AMENDMENTS TO THE DRAWINGS:

REMARKS

Fig.1

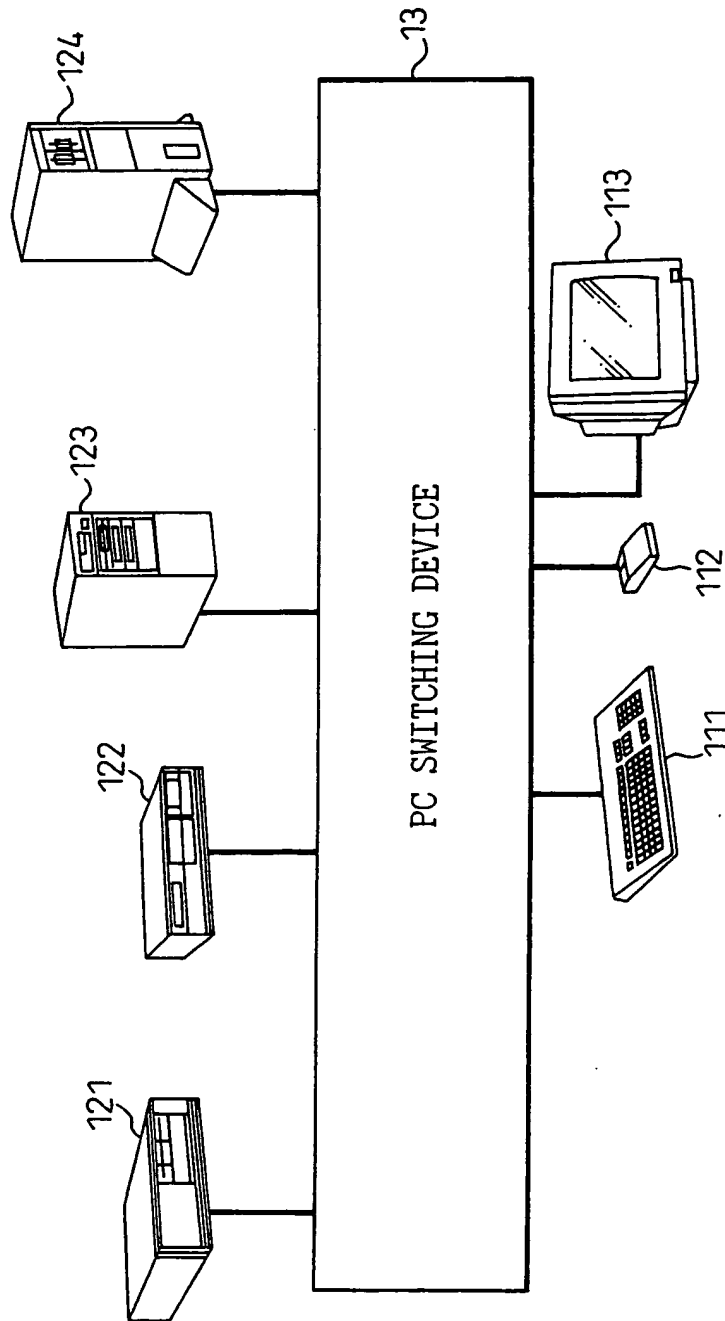
In the Office Action at item 3, the Examiner objected to the drawings in that FIGs. 1-6 should be designated by a legend as --Prior Art--. In order to overcome this objection, replacement figures are submitted herewith, and the legend --Prior Art-- added to FIGs 1-6. Approval of these changes to the Drawings is respectfully requested.

In item 3, the Examiner objects to FIGs. 1-6 and contends that Figures 1-6 should be designated "by a legend such as --Prior Art-- because only that which is old is illustrated." (Action at page 2).

FIGs. 1-6 are amended herein to add the legend --Prior Art--, as the Examiner suggests. Withdrawal of the objection is requested.
